工程指示 / 要求簡箋 ENGINEER INSTRUCTIONS (E.I.)

| 工程指示編號: | EI- 4790D | 修改版本: | D |
| 工程編號: | J 853 | 工程名稱: | 大窩坪 (延坪道) |
| 工程項目: | T3 幕牆單元件生產 (大貨) (修訂D:修改Z字碼設計及修改分格呎吋) | 日期: | 29/07/2022 |

| 名稱 | 頂橫料 | 制圖 | 付吉寧 | 2022.05.20 | 修改 | A |

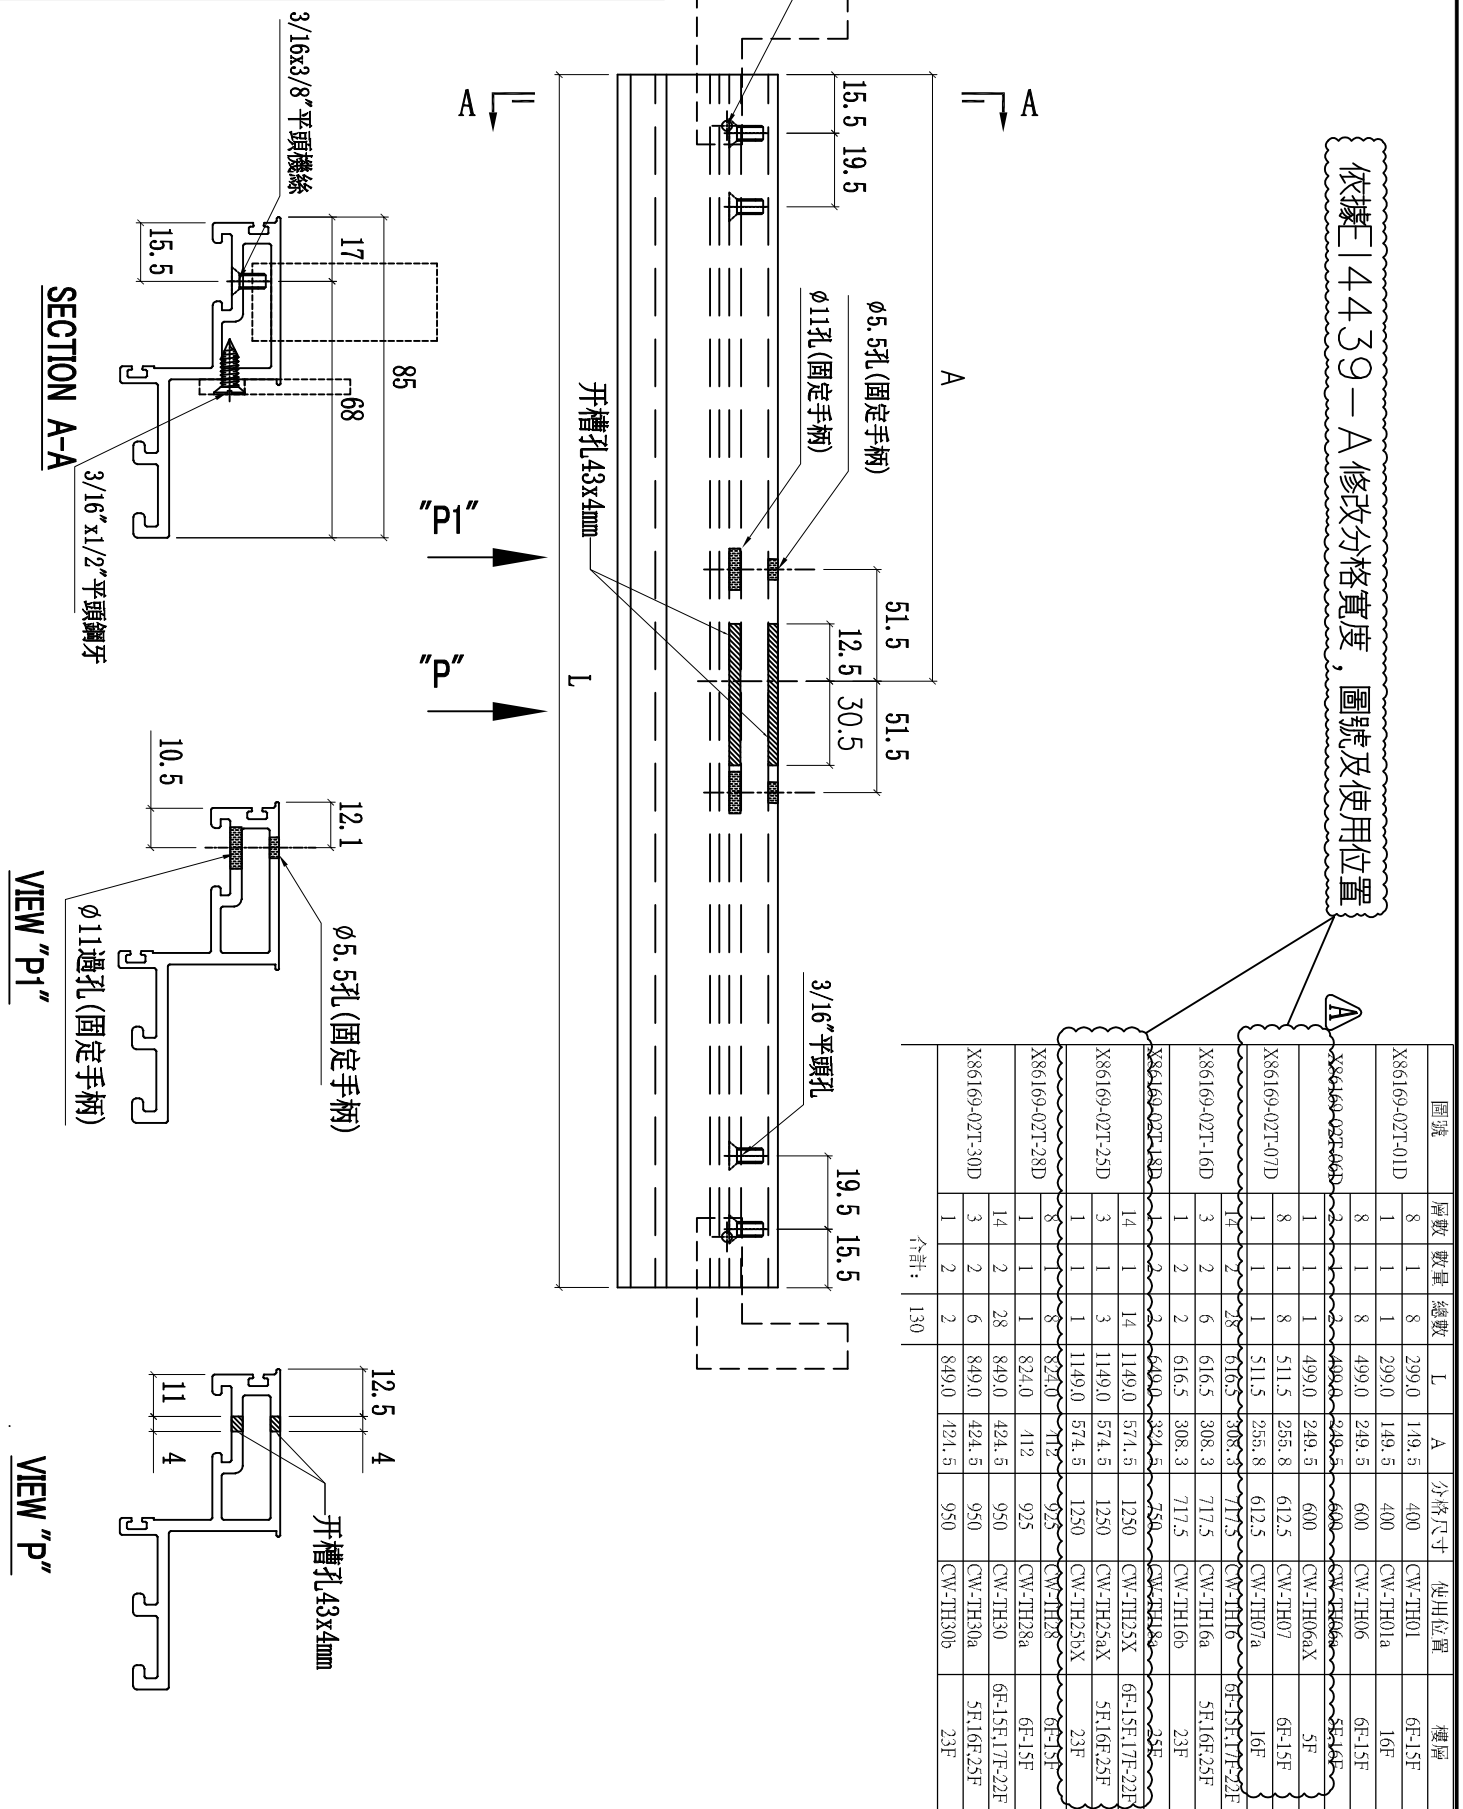
依據E4439-A修改分格寬度，圖號及使用位置

| 名稱 | 多點鎖放樣圖 | 制圖 | 付吉寧 | 2022.05.20 | 修改 | A | | |

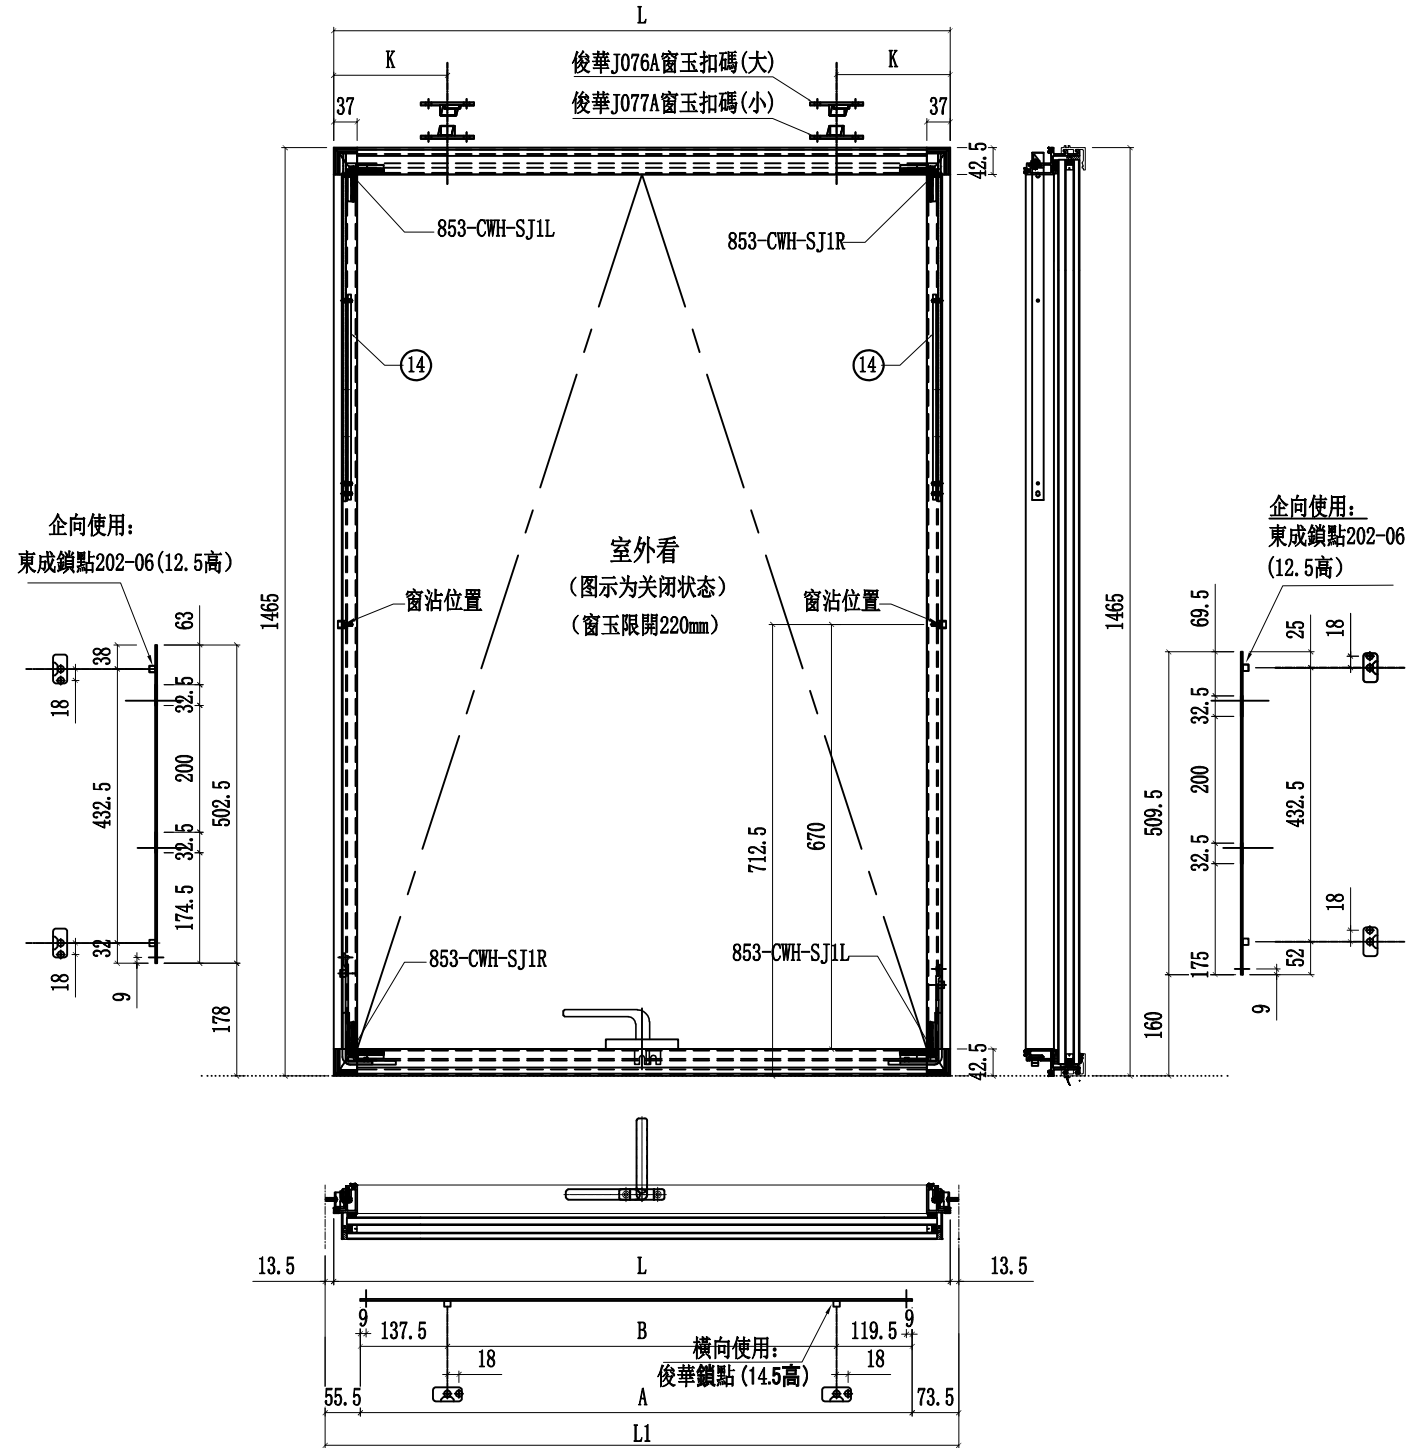
依據 E14439-A 修改分格寬度及物料編號

| 名稱 | 多點鎖放樣圖 | 制圖 | 付吉寧 | 2022.05.20 | 修改 | A | | |

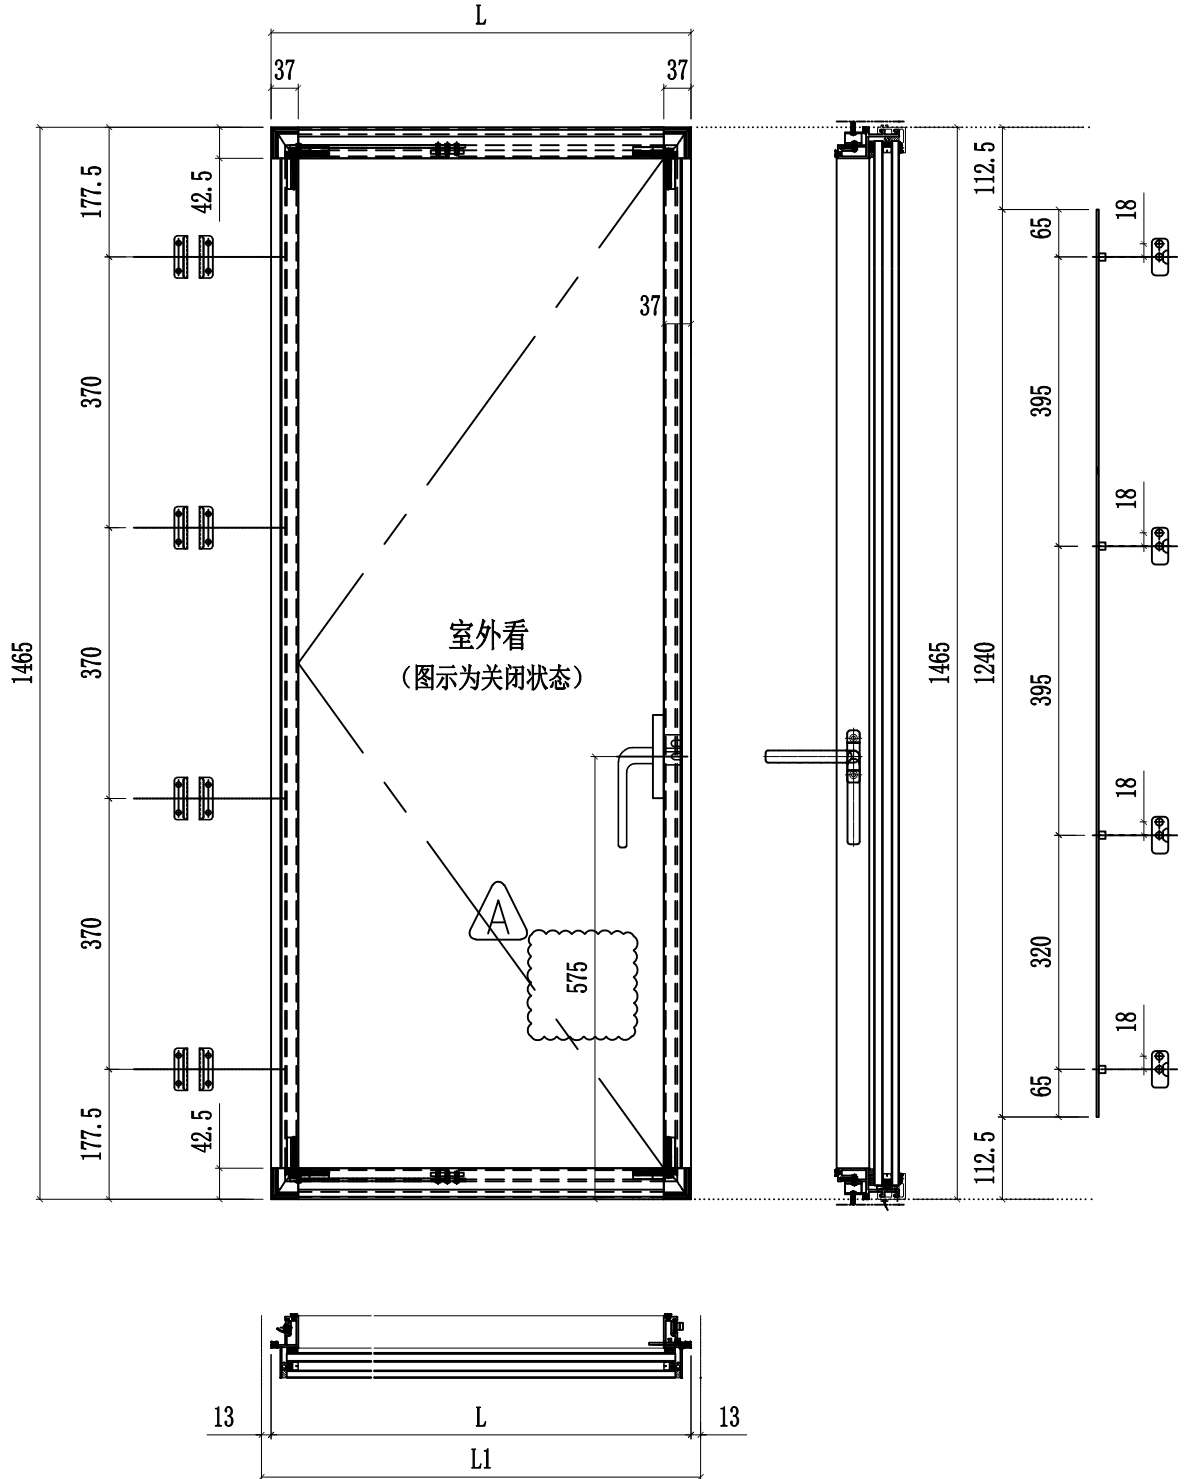
雲線處依據EI-4891 修改手柄高度

| 名稱 | 多點鎖放樣圖 | 制圖 | 付吉寧 | 2022.05.20 | 修改 | A | |

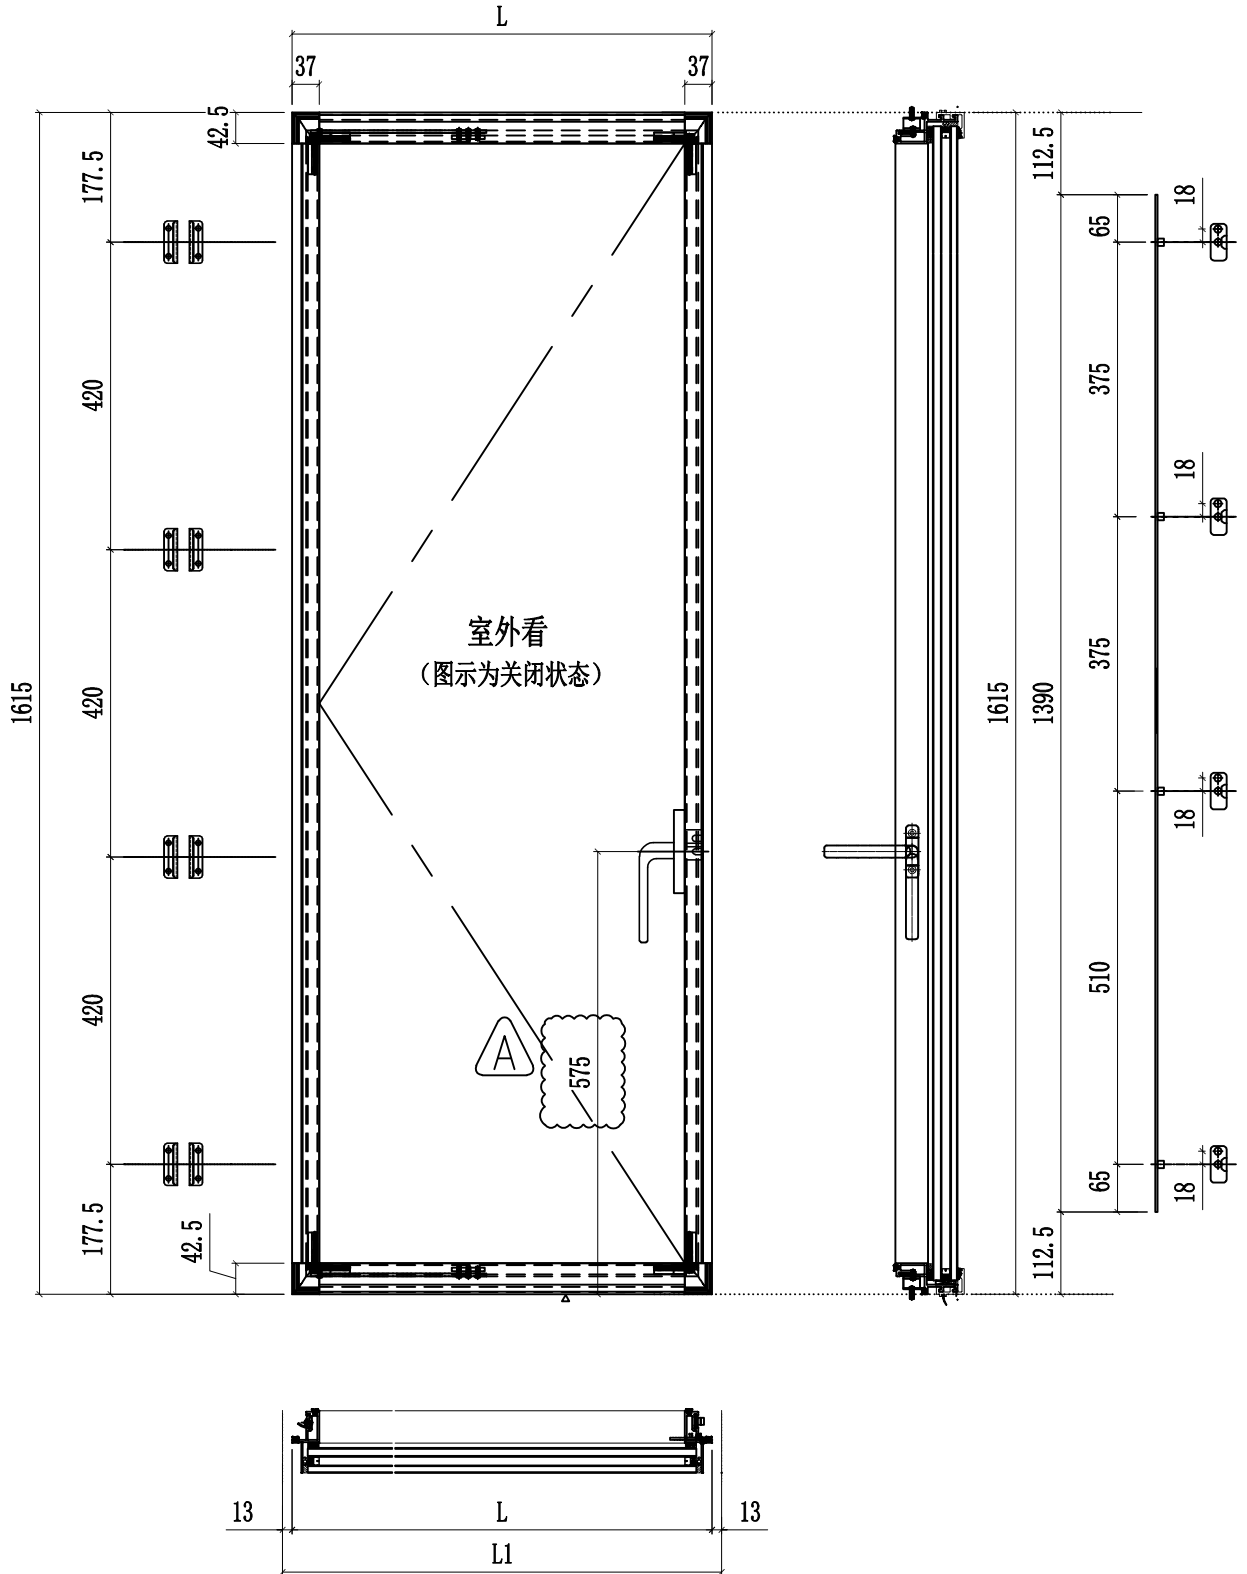
雲線處依據EI-4891 修改手柄高度

| 名稱 | 多點鎖放樣圖 | 制圖 | 付吉寧 | 2022.05.20 | 修改 | A | | |

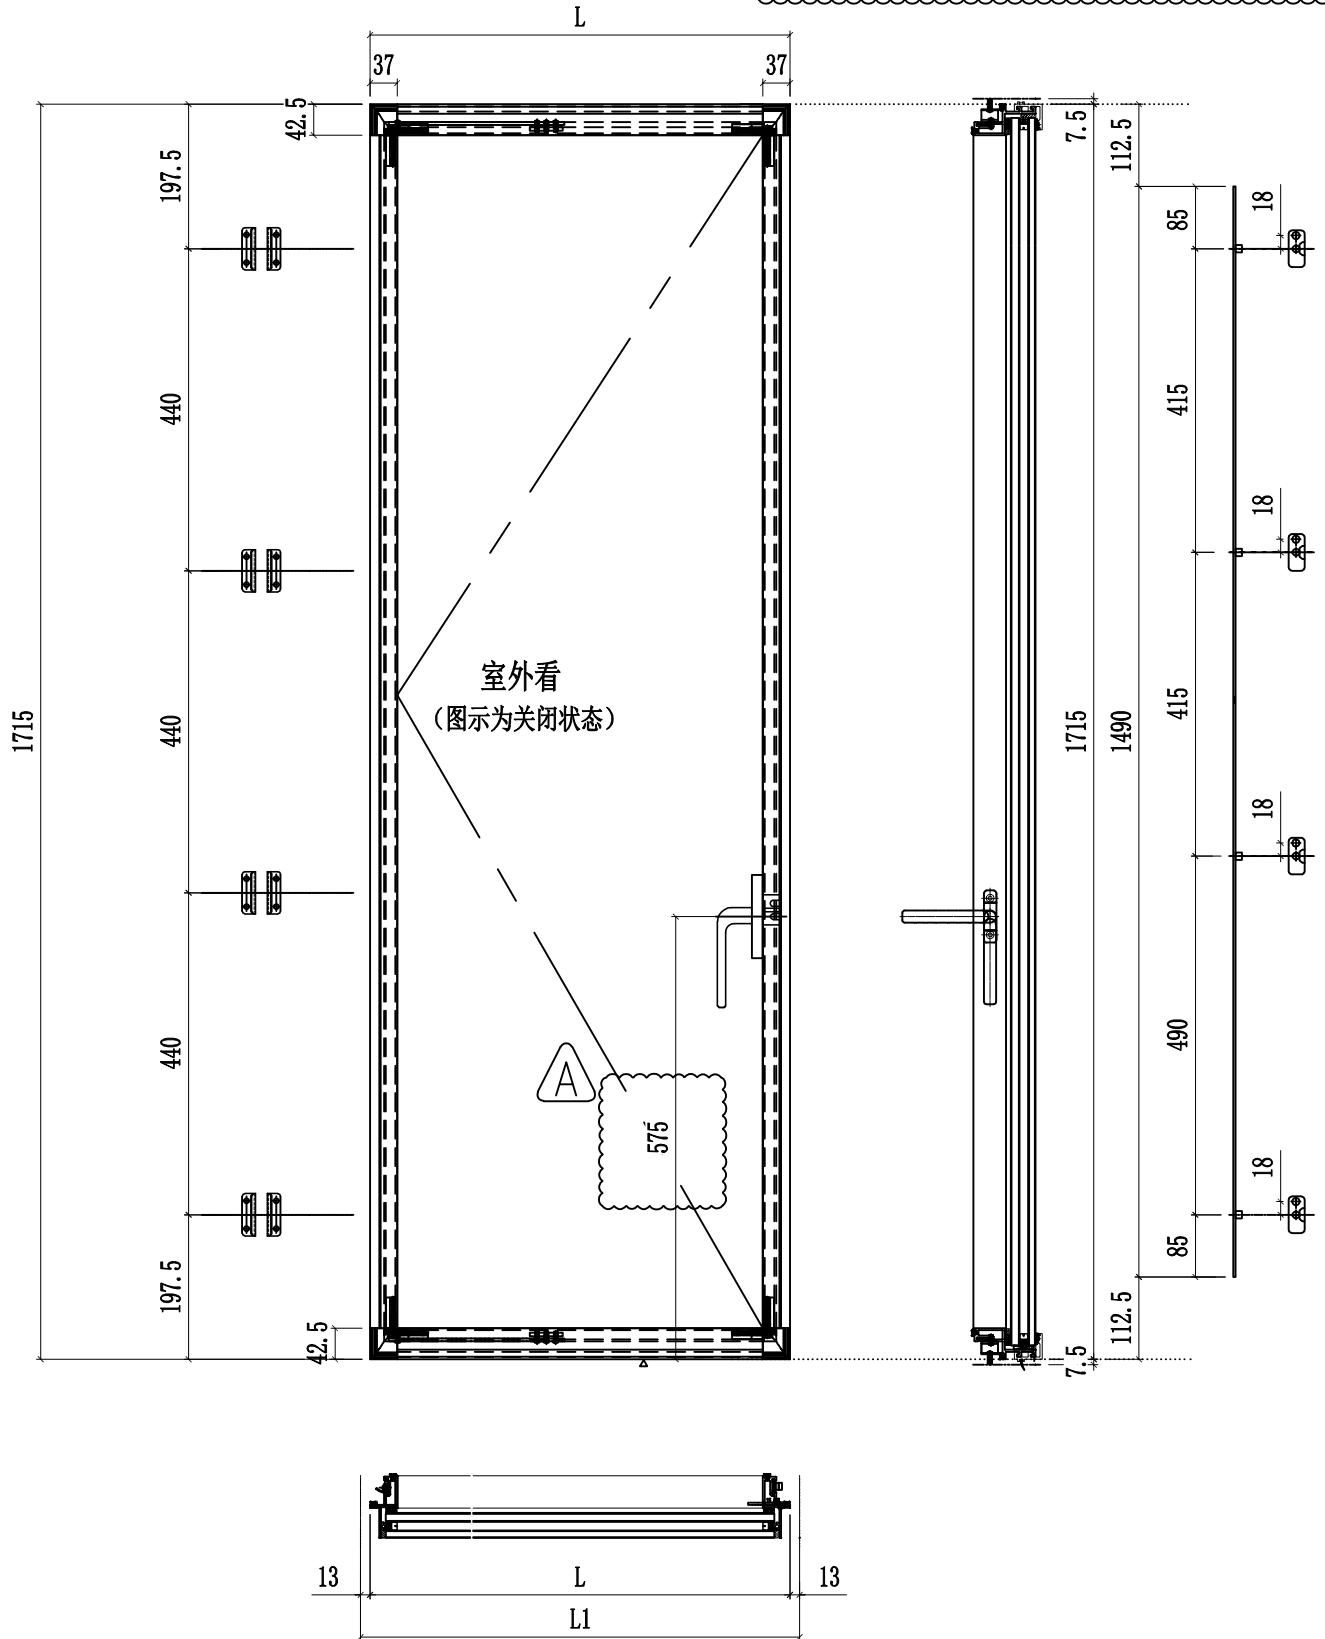
雲線處依據EI-4891 修改手柄高度
